MIL-C-70580B (AR)
AMENDMENT 2
09 October 1992
SUPERSEDING
AMENDMENT 1
04 September 1991

MILITARY SPECIFICATION

CIRCUIT BOARD, 400 Hz INVERTER, VOLTAGE CONVERTER: 9397386

Figure 1. Burn-in Temperature Versus Time Diagram

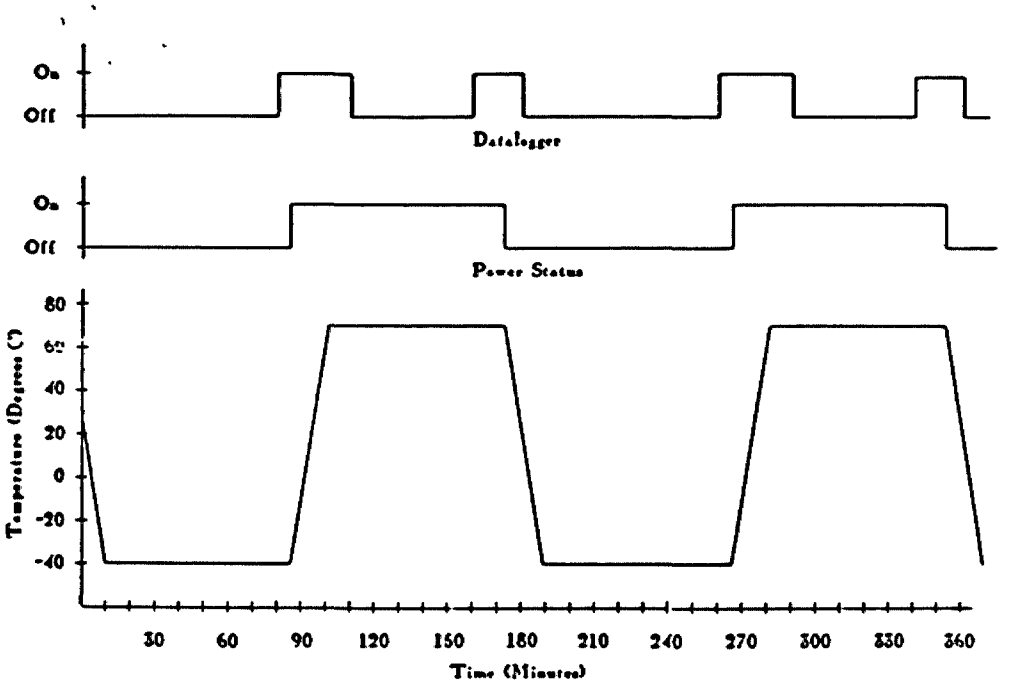
Figure 1: Delete in its entirety and substitute the following:
